Tierra Del Este Unit Ninety Four

City Plan Commission — March 27, 2025

SUMMARY OF RECOMMENDATION: Staff recommends **APPROVAL WITH CONDITION** of Tierra Del Este Unit Ninety Four on a Major Combination basis, subject to the following condition:

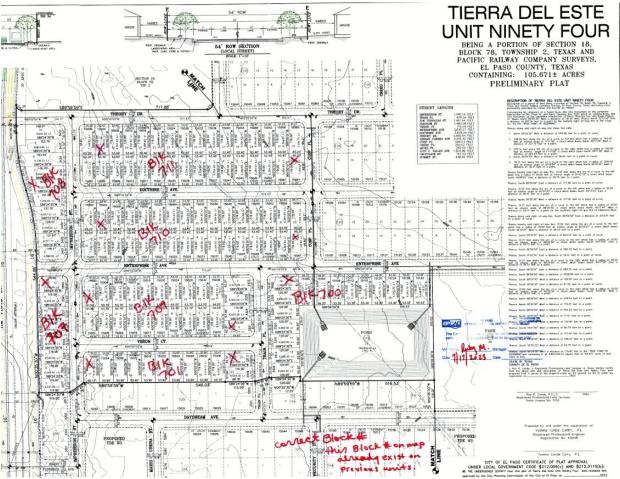
Please see attachment for recommendations on traffic calming locations

El Paso Central Appraisal District

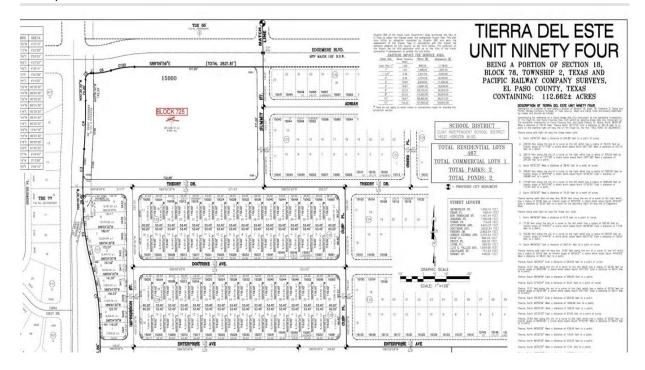
There is portion (block 151) that was not on the previous maps. Added Blk 725 instead of block 151 which is already in another unit.
